MCPB
Item #
12-6-10

MEMORANDUM

TO: Montgomery County Planning Board
VIA: Mark Pfefferle, Acting Chief, Environmental Planning
FROM: Josh Penn, Senior Planner, Environmental Planning
DATE: November 23, 2010
PLAN NAME: A-305 Snowden Farm Parkway
PLAN NUMBER: MR 2010814
PLAN TYPE: Preliminary Forest Conservation Plan
Special Protection Area Water Quality Plan
REVIEW BASIS: Chapter 22A of the County Code
Chapter 19 of the County Code
ZONE: RE-2
LOCATION: West of Ridge Road (MD 27) 800 feet south of Morning Star Drive in
Clarksburg
APPLICANT: Montgomery County Department of Permitting Services (DPS)
HEARING DATE: December 6, 2010

Re: Revised Final Water Quality Plan for
Snowden Farm Parkway A-305
SM File #: 233038
Tract Size/Zone: 12.6 acres/RE-2,C-Inn
Total Concept Area: 6.5 acres
Watershed: Little Seneca Creek

Figure 2: Areas of Concern

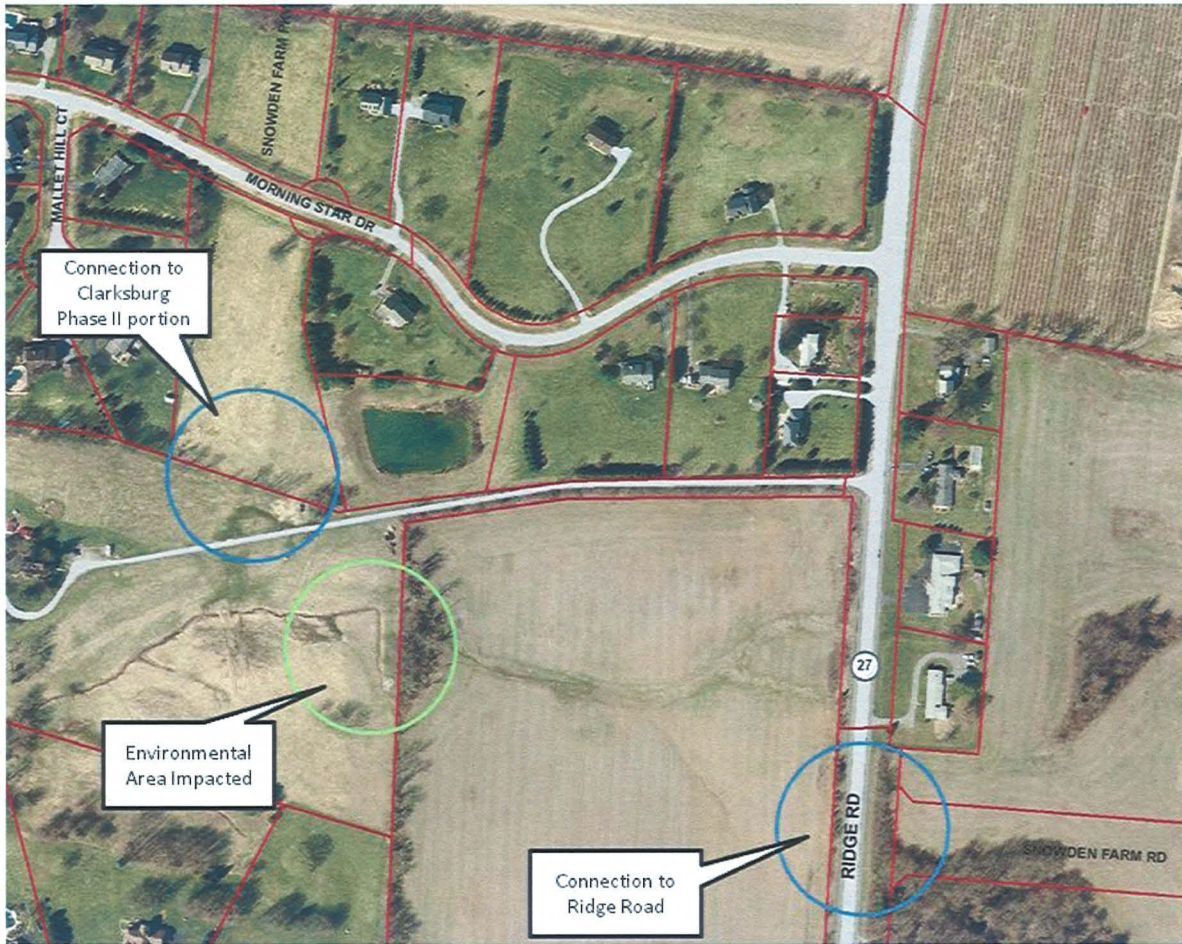
The applicant made a number of alterations to the typical roadway cross section to reduce the necessary environmental impacts. In the area of the stream crossing and wetlands, as outlined in green in the exhibit below, the modified cross section reduces wetland impact by 720 square feet (new total 4,943 SF) and wetland buffer impact by 600 square feet (new total 16,931 SF compared to the typical cross section).
